NIE Networks' Small Scale Generator Interface Protection Amendment Project

Consultation Report

19/02/18

FIGURE 1 - SSG RISK OF FATALITY

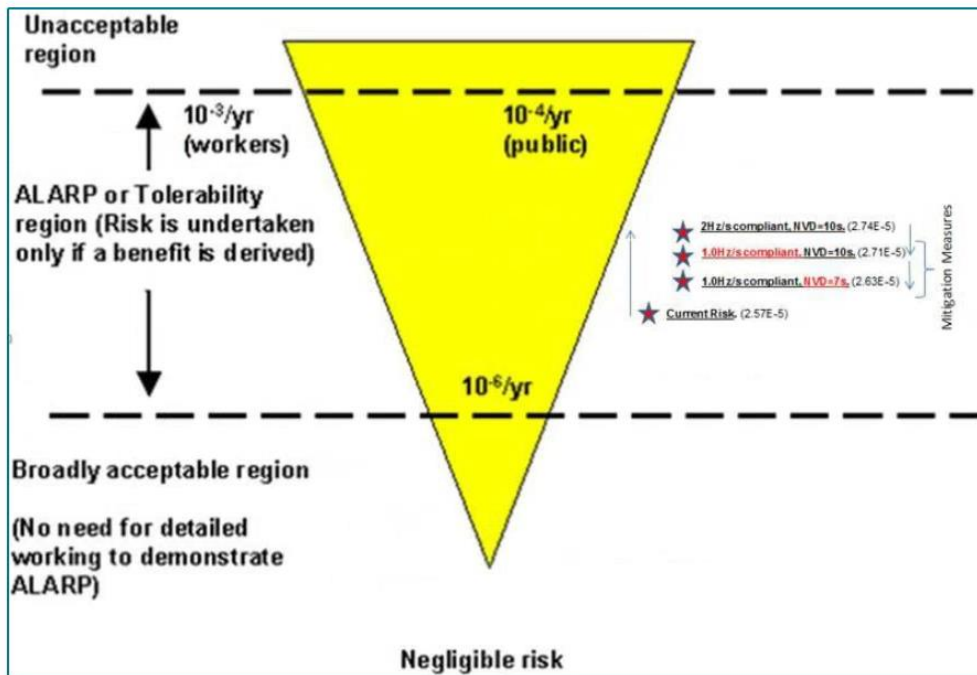
The impact of the risk mitigation measures on risk of electrocution are shown in Figure 1. It can be seen that compliance with a 1Hz/second standard as opposed to a 2Hz/second standard offers a risk reduction moving the risk closer to the current risk level.
